1st Further Information

**Proposed Temporary Warehouse (Excluding Dangerous Goods Godown) and
Associated Filling of Land for a Period of 3 Years in "Agriculture" Zone,
Lots 1355 (Part) and 1357 (Part) in D.D. 82 and adjoining Government Land,
Ping Che, Ta Kwu Ling, New Territories**

(S.16 Planning Application No. A/NE-TKL/854)

(Application No. A/NE-TKL/854)

DWG. TITLE
FILLING OF LAND

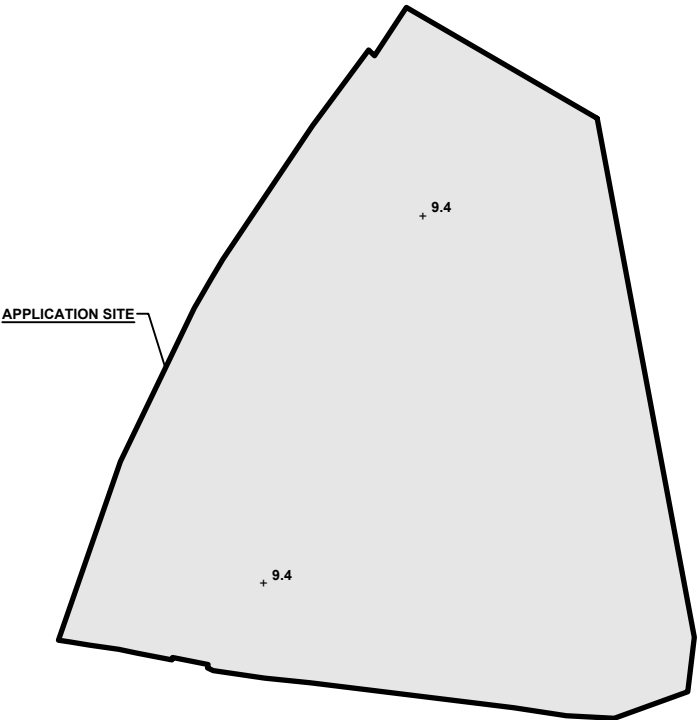
- (i) The applicant would like to clarify that the application site (the Site) has been fully paved with concrete of not more than 0.2 m, where the existing level is +9.4 mPD (about). This is to create a flat surface for site formation of structure and circulation space. Such land filling is considered necessary and has been kept to minimal to meet the operational needs of the proposed development. Revised land filling plan is enclosed at **Appendix II**; and
- (ii) The applicant would like to submit a response-to-comments table for the consideration of government bureaux/departments:

APPLICATION SITE AREA	: 569 m ²	(ABOUT)
PROPOSED FILLED AREA	: 569 m ²	(ABOUT)
DEPTH OF LAND FILLING	: NOT MORE THAN 0.2 m	
PROPOSED SITE LEVELS	: +9.4 mPD	(ABOUT)
MATERIAL OF LAND FILLING	: CONCRETE	
USE	: SITE FORMATION OF STRUCTURE, AND CIRCULATION SPACE
